Addendum #03

CSD22-001 -S.G. Nesbitt Memorial Arena Concession Stand Supply and Renovation

PROJECT NAME	55 PARKSIDE ST., MINDEN, ON - SG NESBITT MEMORIAL ARENA CONCESSION STAND FIT-UP
PROJECT NO.	GWAL 2021-439
DATE	NOVEMBER 16, 2022
ADDENDUM NO.	E1

PROJECT NAME	55 PARKSIDE ST., MINDEN, ON - SG NESBITT MEMORIAL ARENA CONCESSION STAND FIT-UP
PROJECT NO.	GWAL 2021-439
DATE	NOVEMBER 16, 2022
ADDENDUM NO.	M2

rawing title/Titre du dessin MECHANICAL FIRE PROTECTION & **HVAC REVISIONS**

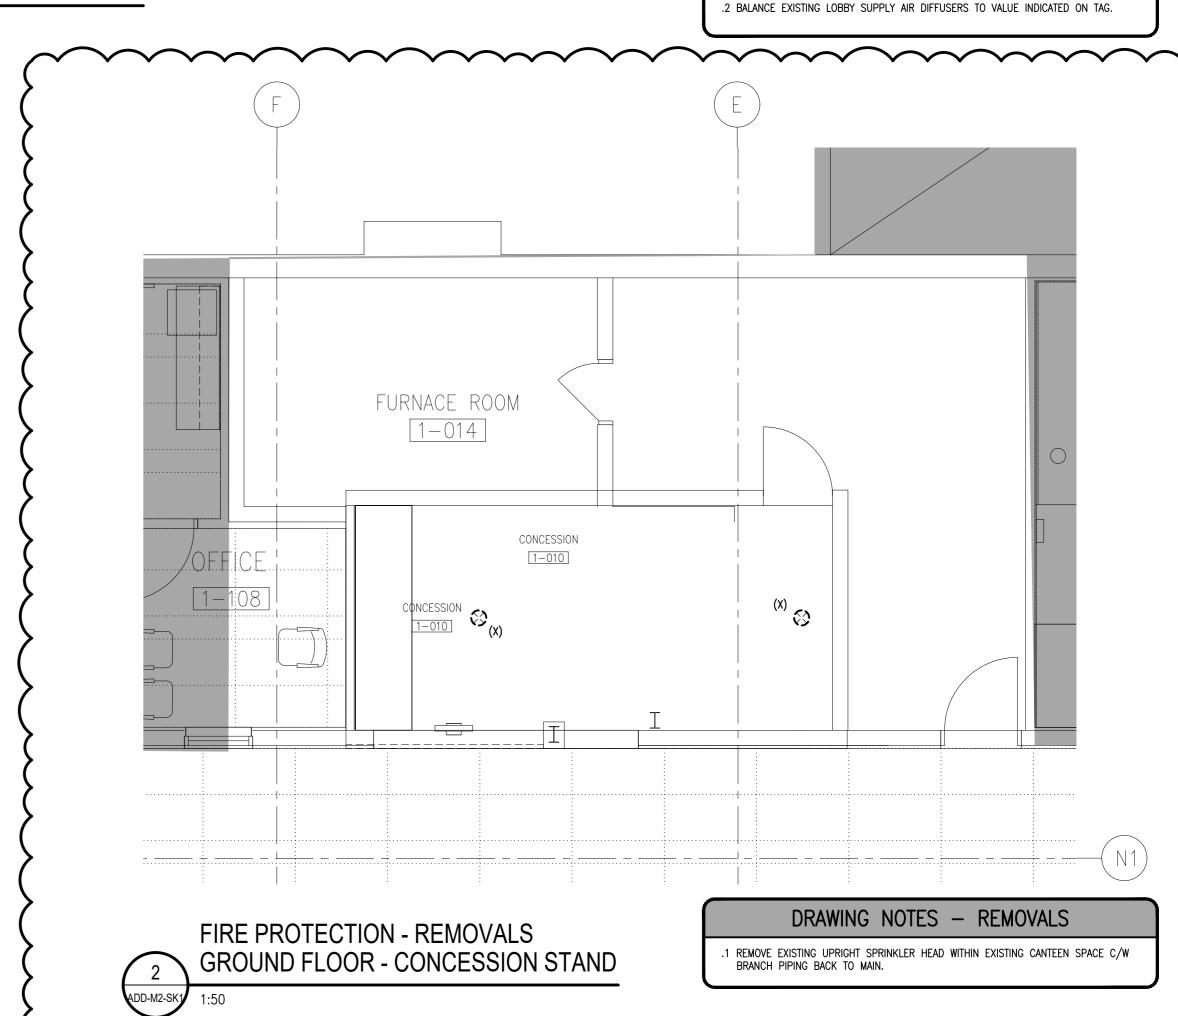
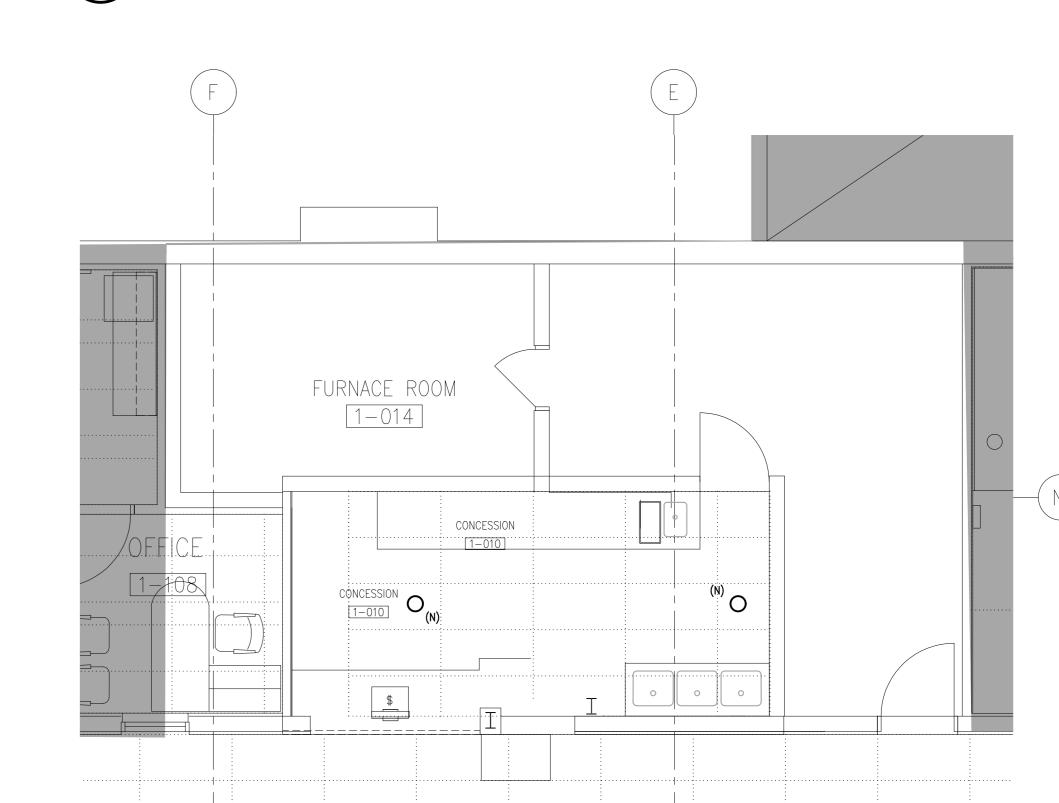
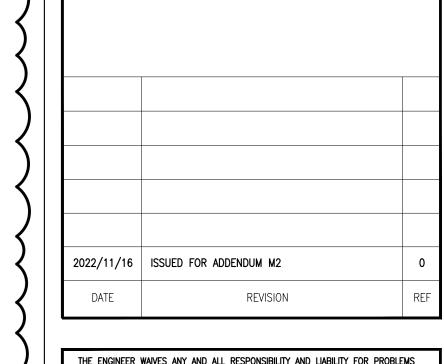
- 1. Reference Drawings M1 and Attached Sketch ADD-M2-SK1:
 - 1.1 Remove existing upright sprinkler heads within existing canteen space.
 - 1.2 Provide new pendent sprinkler heads within new canteen T-bar ceiling. Refer to specification for material details.
 - 1.3 Provide supply air diffuser within canteen T-bar ceiling c/w flexible ductwork where indicated.

PROVIDE SUPPLY AIR DIFFUSER WITHIN CANTEEN WHERE INDICATED, REFER TO

SCHEDULE FOR DETAILS. BALANCE TO VALUE INDICATED ON TAG.

.1 PROVIDE NEW PENDENT SPRINKLER HEAD WITHIN NEW CANTEEN T-BAR CEILING

C/W BRANCH PIPING BACK TO MAIN. REFER TO SPECIFICATION FOR MATERIAL
